Newsome Mills

Transport Statement v1.1

27 April 2023

TITLE
 SITEWIDE VISI-SPLAYS

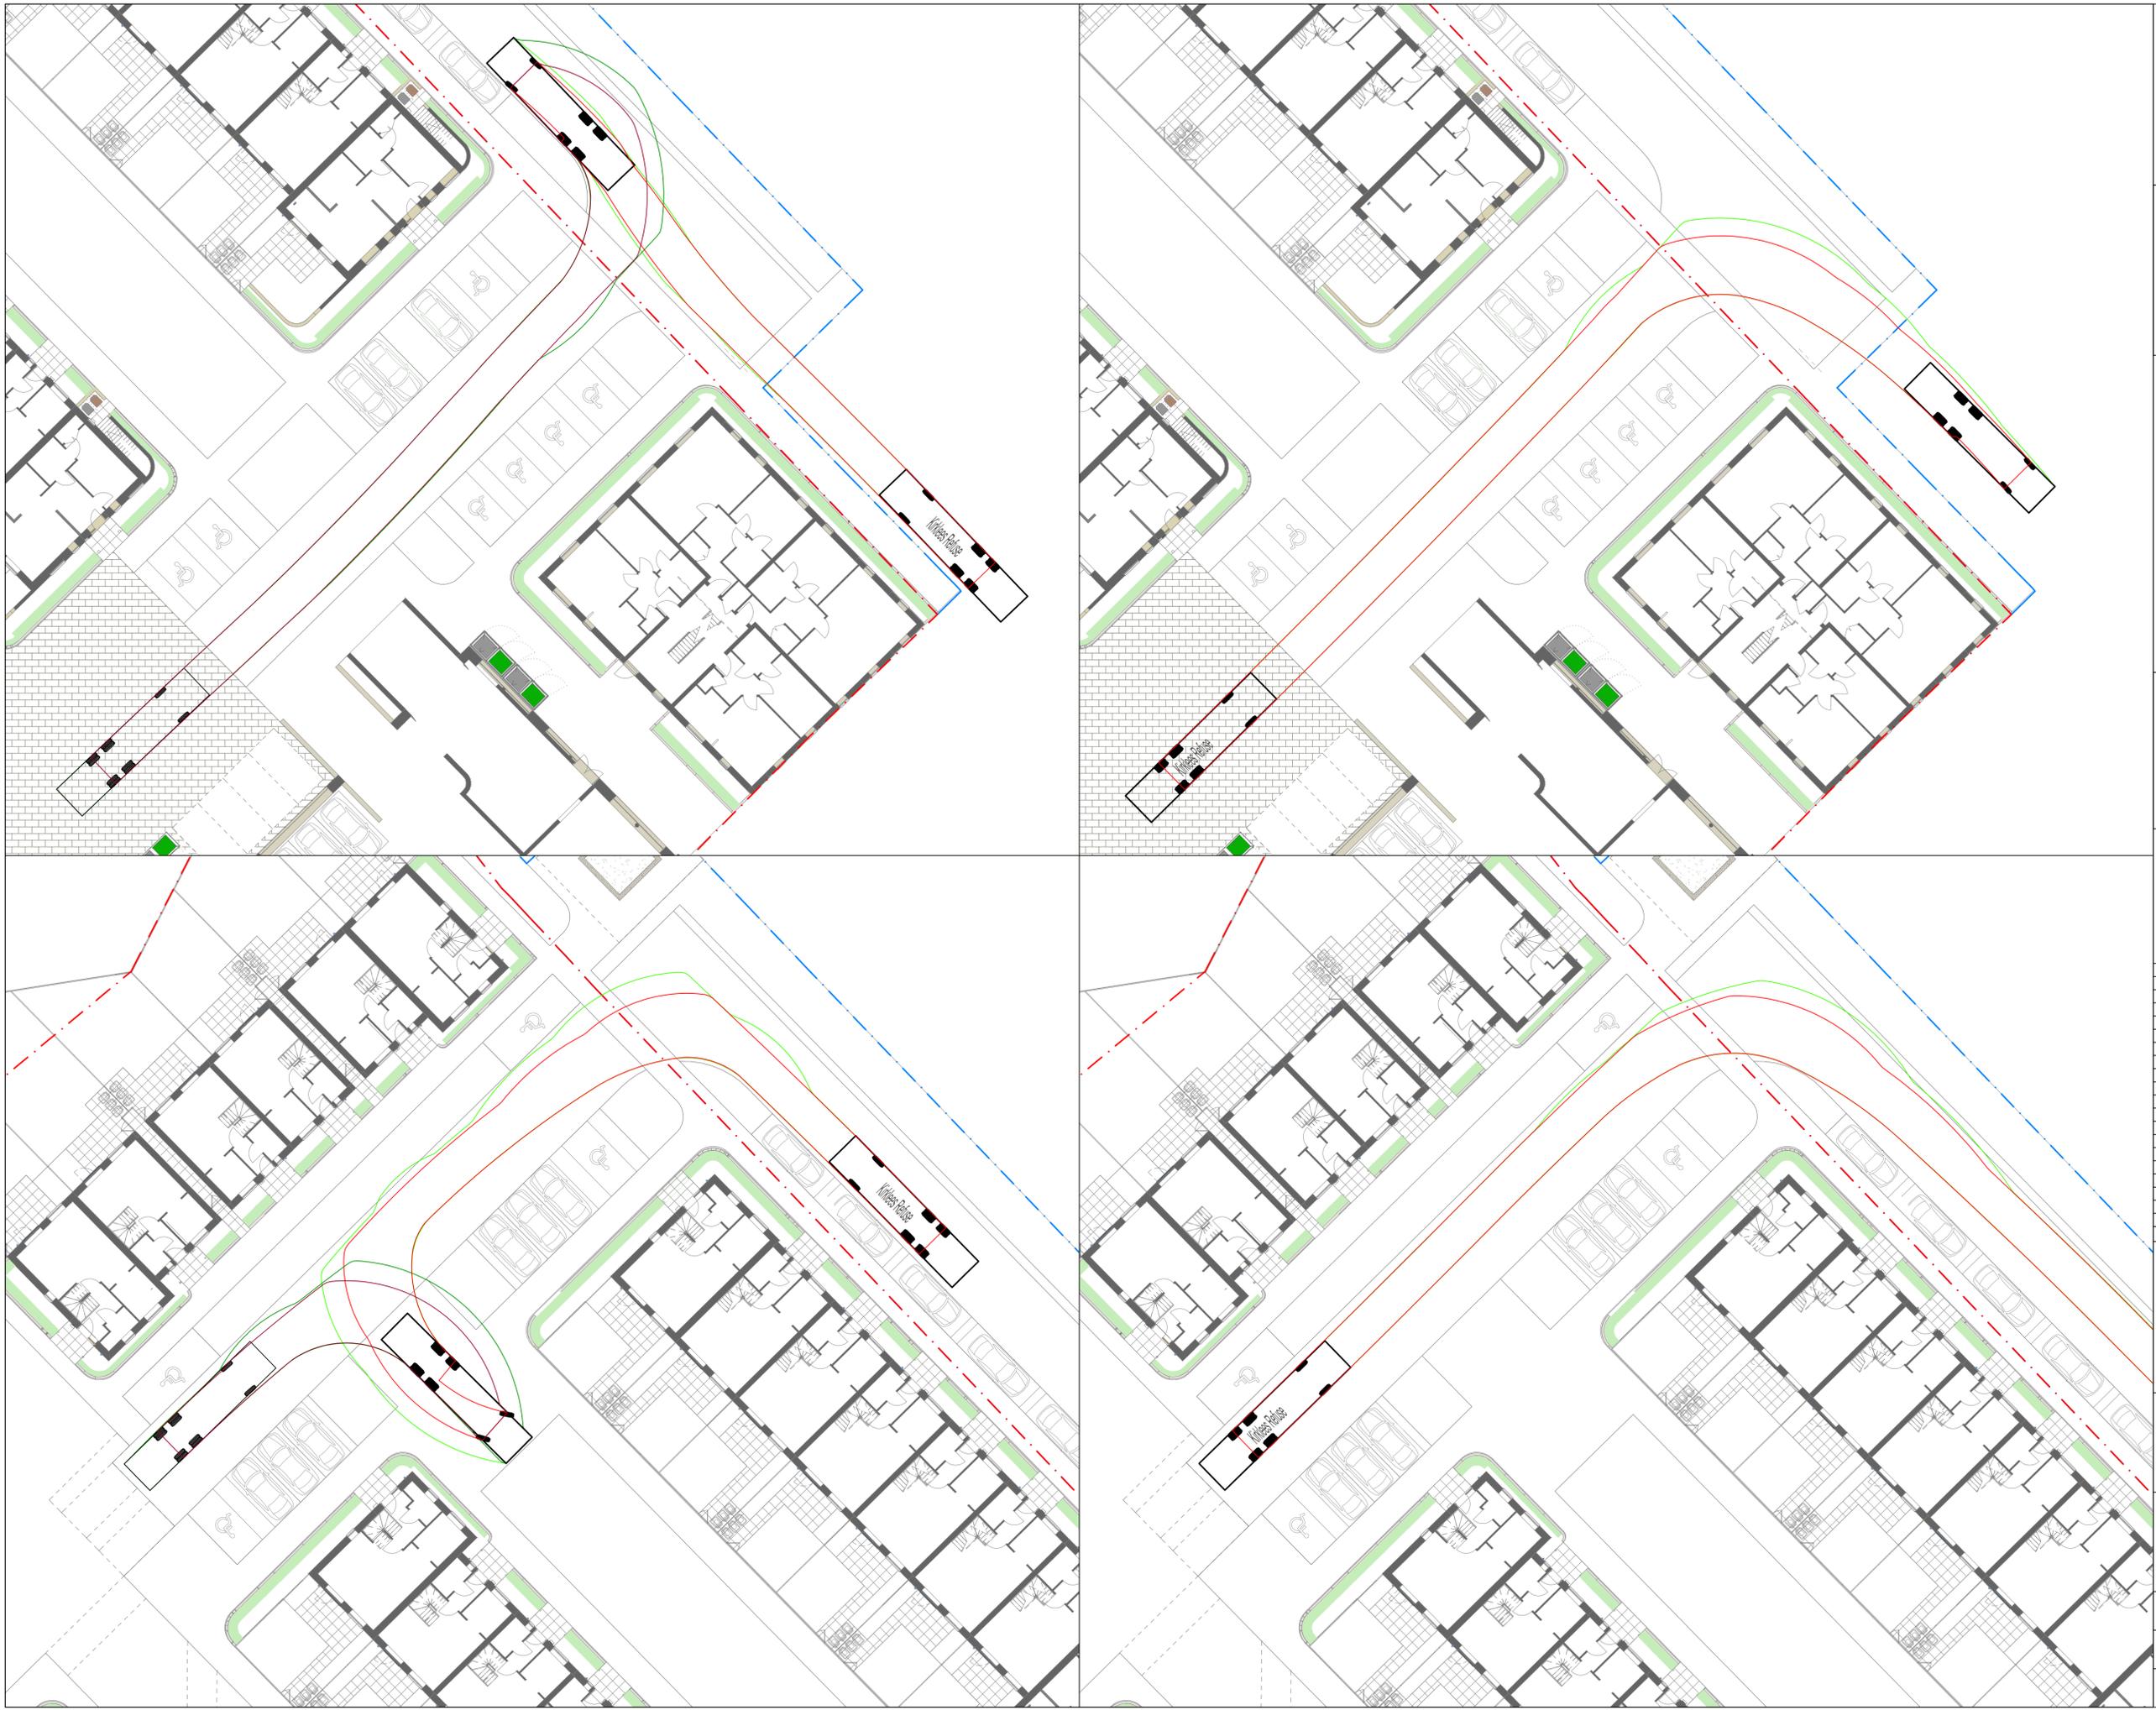
<p>As of the adoption of the Local Plan Kirklees Council no longer has car parking standards. Policy LP22 sets out the criteria for establishing parking requirements for new developments, which should be evidence based within the planning application submission.</p>	<p>The criteria set out in Policy LP22 has been used to determine the proposed parking levels, see section 4.5.</p>
<p>A stage 1 safety audit and designers response is required.</p>	<p>A Stage 1 Road Safety Audit is being progressed and the audit and designers' response will be provided when available.</p>
<p>Visibility splays and forward visibility envelopes should be demonstrated and achievable within the adopted highway.</p>	<p>Provided in Appendix C.</p>

Visibility splays have been provided for the new junction on Hart Street into the site and forwards visibility around the corner within the site, these are provided in Appendix C. Parking and other features within visibility splays are common in urban environments. Vehicles parked in the visibility splays result in drivers edging out streets. This is appropriate here, where traffic is low, and speeds
